**WHEELING PLAN COMMISSION
THURSDAY, SEPTEMBER 13, 2018 6:30 P.M.**

**AGENDA FOR A REGULAR MEETING OF THE PLAN COMMISSION
Board Room - 2 Community Boulevard, Wheeling, Illinois**

RE: **Docket No. PC 18-15**
Pizza Roncadin
236 Egidi Drive
Minor Site Plan and Appearance Approval of a Nitrogen Tank

RE: **Docket No. 2018-23**
H2O Express Car Wash
966 S. Milwaukee Avenue
Special Use-Site Plan Approval of a Car Wash Facility

00.00.00 ISSUED FOR PERMIT
REVISIONS
DRAWN BY: RAM
APPROVED BY: MCM / GCN
SCALE: AS NOTED
DESCRIPTION: LANDSCAPE PLAN

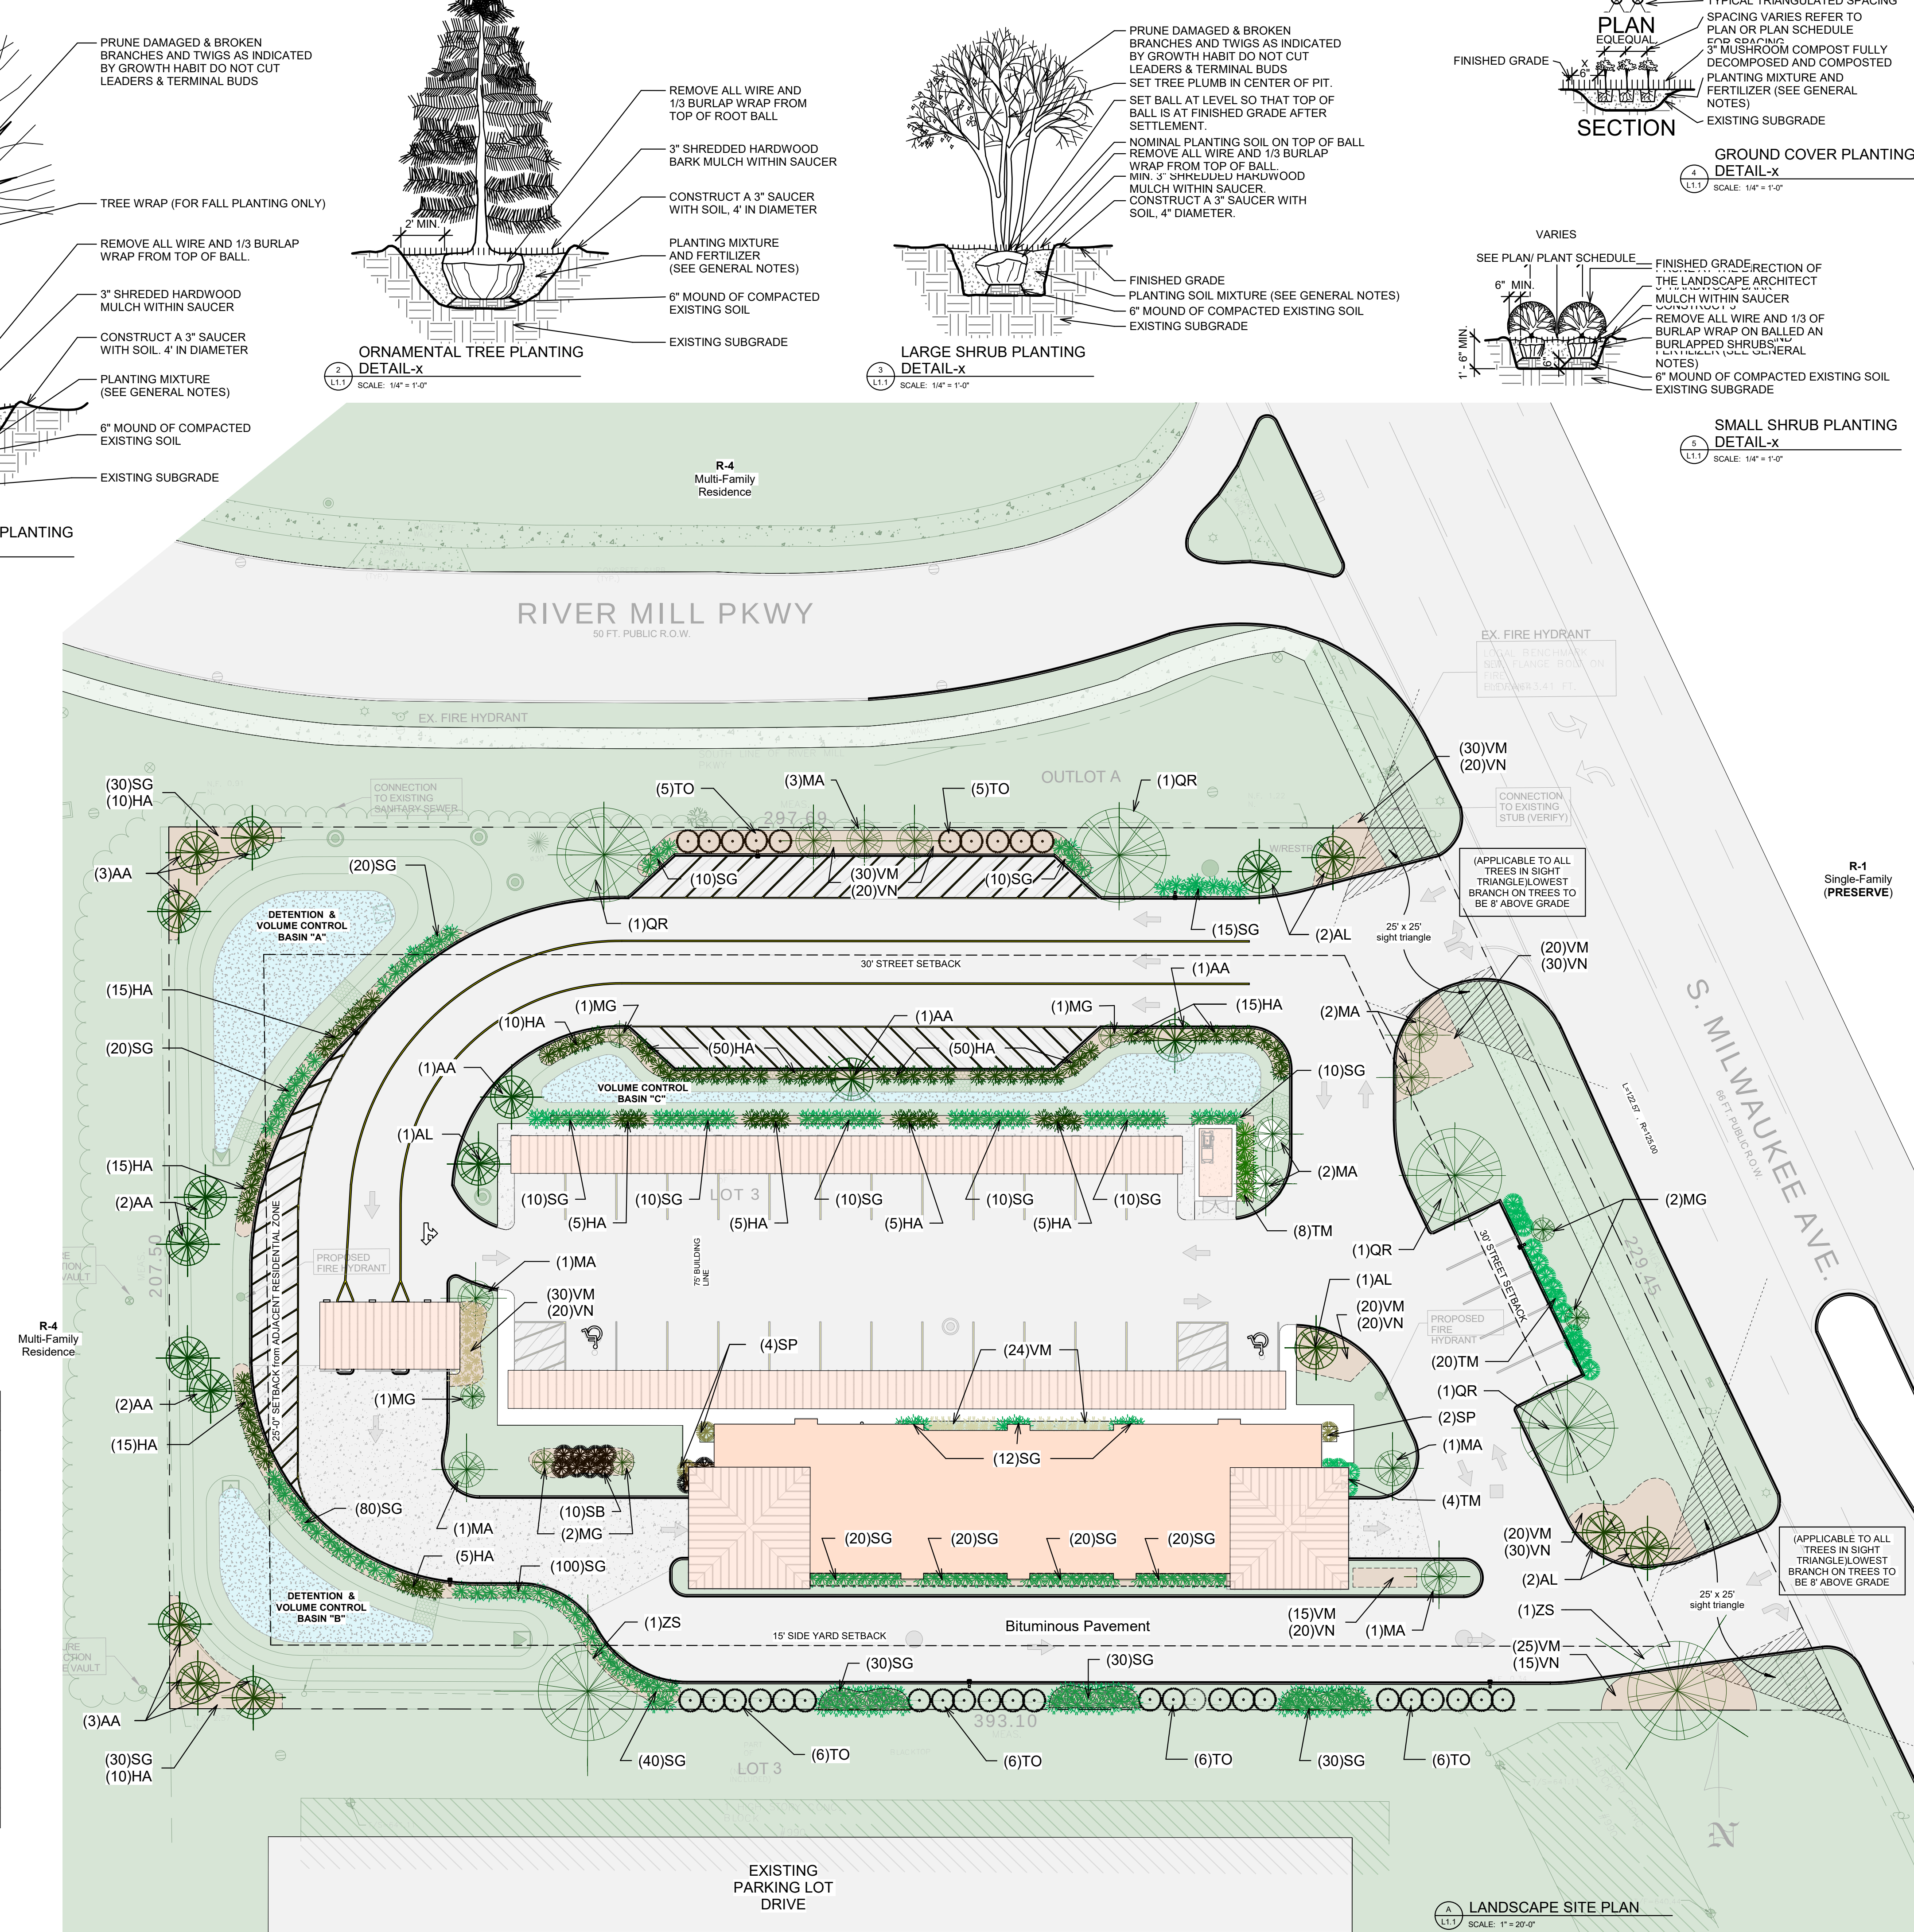
Proposed Landscaping: Landscaped screening is provided on the perimeter of the site and surrounding the parking areas. See the note below for screening from residential. Additional building foundation plantings are provided. Detention basins are proposed for the northwest and south west corners of the site.

Irrigation: Irrigation is required by code. No irrigation details are provided. The Plan Commission may wish to discuss which areas shall be irrigated and consider a condition of approval regarding irrigation.

Screening from residential: The Zoning Code indicates that "*off-street parking* areas, including aisles and *driveways*, shall be effectively *screened* year round, on each side of any *off-street parking* lot for six (6) or more vehicles that adjoins any property used for residential purposes or situated in a residential district, by a wall, *fence* or densely planted compact hedge not less than five (5) feet nor more than six (6) feet in height." It does not appear that this requirement is met. The River Mills Subdivision is located directly north and west of the subject property. While vegetative screening is provided, it will not provide year-round screening five to six feet in height. The Plan Commission may wish to discuss options with the petitioner. A solid fence along the north and west property lines would meet this requirement.

00.00.00	ISSUED FOR PERMIT
REVISIONS	
DRAWN BY:	Author
APPROVED BY:	Checker
SCALE:	AS NOTED
DESCRIPTION:	ROOF & TOWER PLANS
SHEET NO.	A-2.3

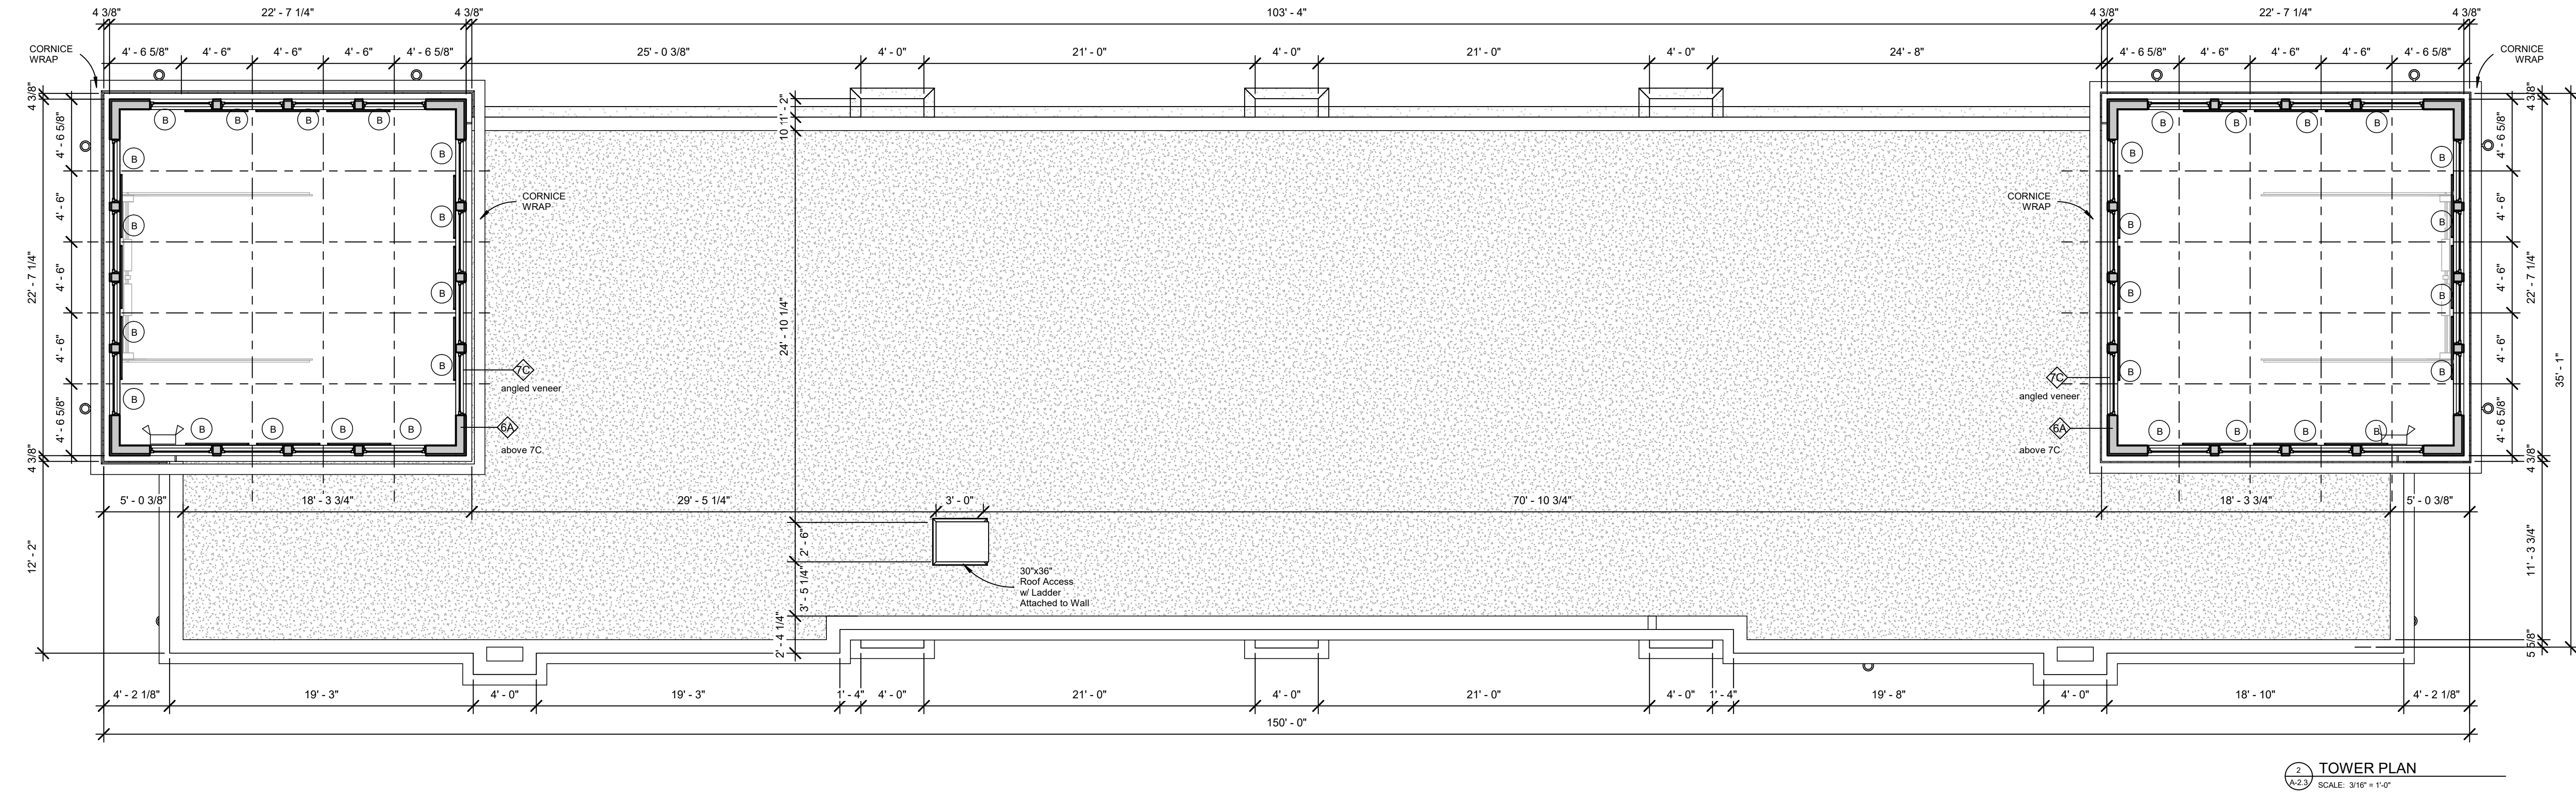
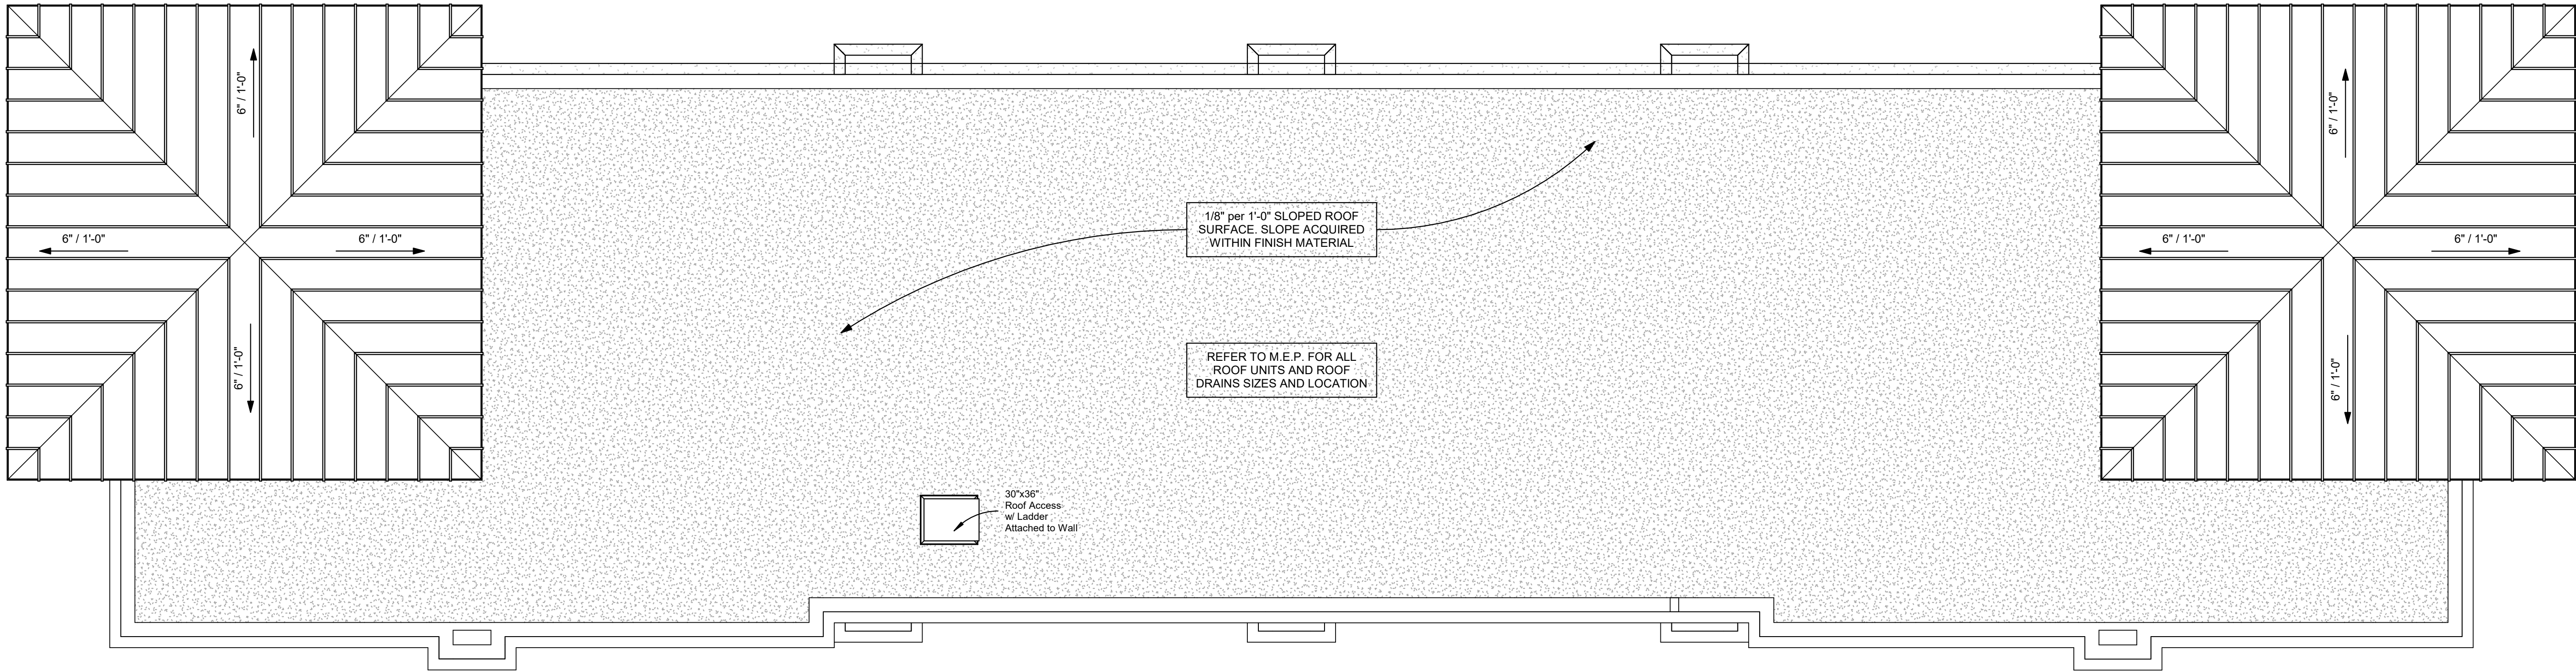
HVAC/Mechanical Components Screened: No details are provided. However, the flat portion of the building roof includes a 3'8" parapet. Between the tower elements at the ends of the building and the parapet between them, roof-top mounted mechanicals would likely be screened. The Plan Commission may wish to verify all mechanical units are adequately screened.
